Agency: Nuclear Regulatory Commission

Title: Advisory Committee on Reactor Safeguards
355th ACRS General Meeting

DATE: Friday, November 17, 1989 PAGES: 205 - 372

8 During today's meeting the Committee will discuss the
9 GE Advanced Boiling Water Reactor, ABWR, and continue our
10 discussion from yesterday of Generic Issue 87, the HPCI Steam
11 Line Break without Isolation, and we'll hear and discuss ACRS
12 subcommittee activity reports on planning and procedures, a
13 discussion of selection of ACRS members and officers and
14 preparation of any reports.

CWD 4.6-6A

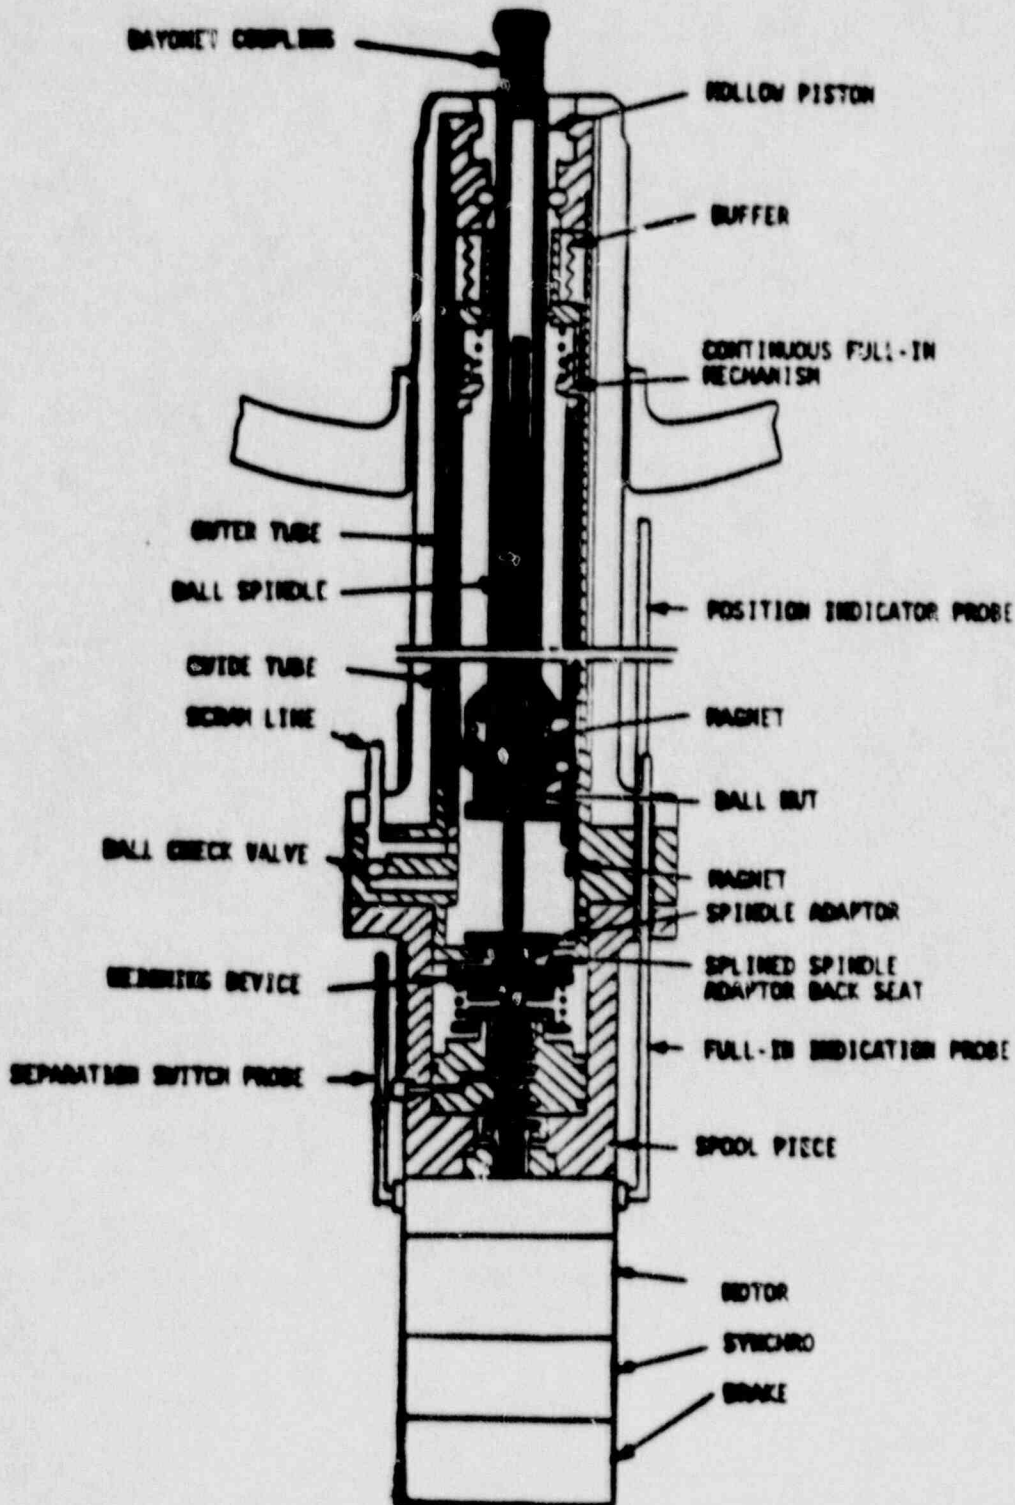
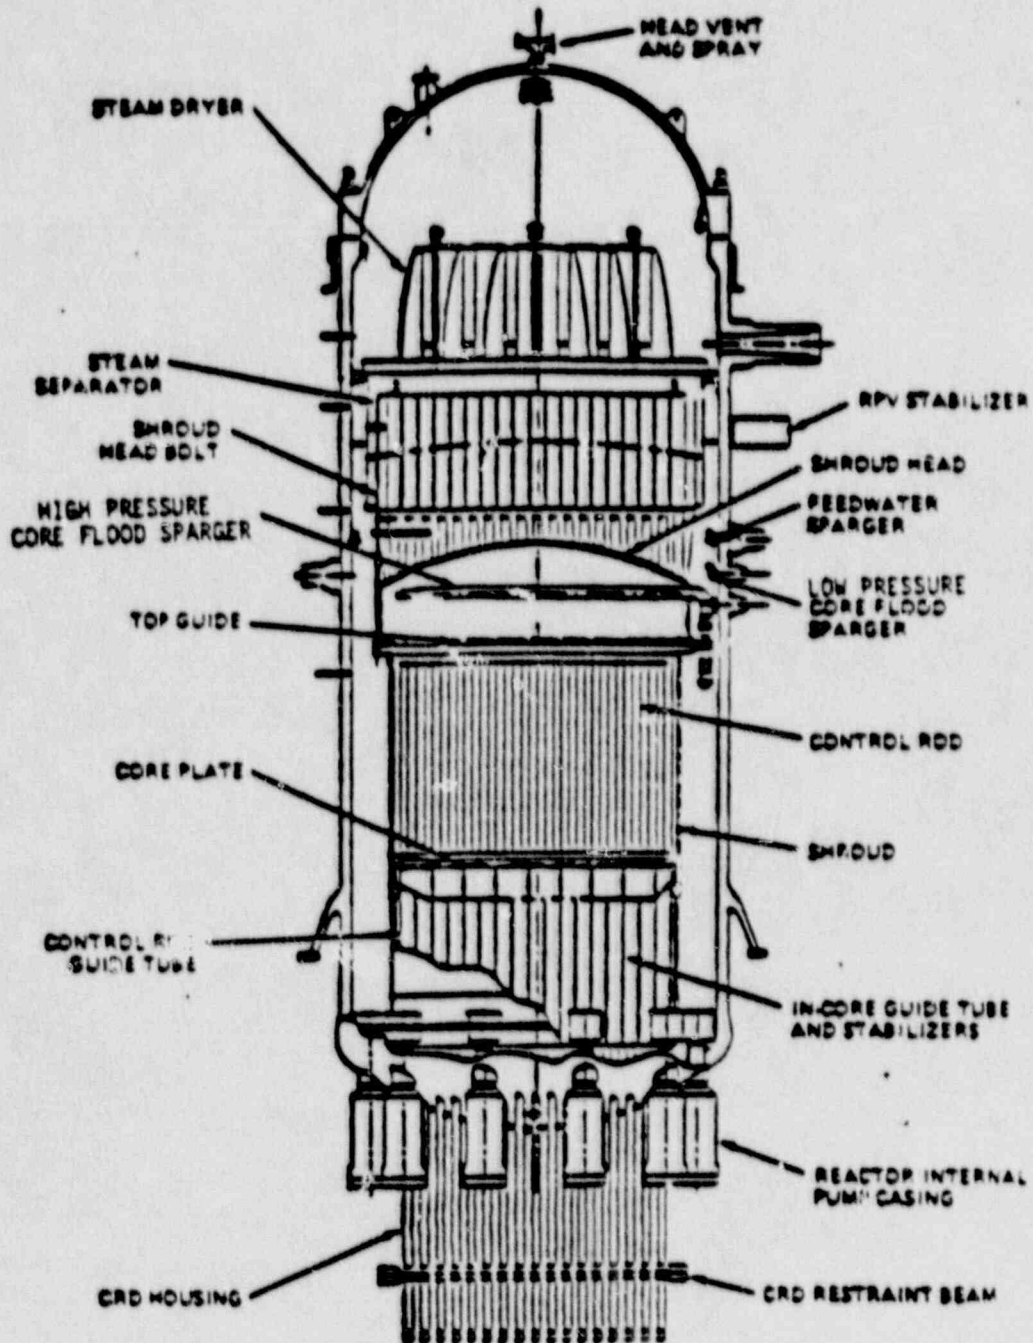
24 MR. MICHELSON: One of the things that bothers me a
25 little bit on the figure you showed of the housing is that in

4 Now, what drawings in the SSAR will show those
5 additional welds so that we're assured the staff has reviewed
6 this thing properly or do they get the drawings of the vessel
7 itself to review?

10 MR. MICHELSON: It's no any detail. In terms of this
11 drawing, it's just coloring in another weld and it's an
12 important one because you explain how that weld, even if the
13 weld of the housing shears, that there is a collar formation
14 that prevents it from being ejected. That I wouldn't have
15 gotten from looking at your drawing.

16 It's not a big deal. It's not a big job. I don't
17 know what we're certifying ultimately. I think it's the SSAR
18 and, if it isn't shown in the SSAR, then people can come in
19 with a number of modifications of that arrangement that would
20 be automatically certified because it's not a part of our SSAR.

14 MR. MICHELSON: I think you ought to be made aware of
15 that, and this is the drawing that should have showed it. If
16 your metallurgists had any problem with it, then they could
17 ask. So I don't think it's a big deal, but it's an important
18 feature.

19 MR. DILLMANN: We'll clarify that drawing in
20 subsequent cleanup.
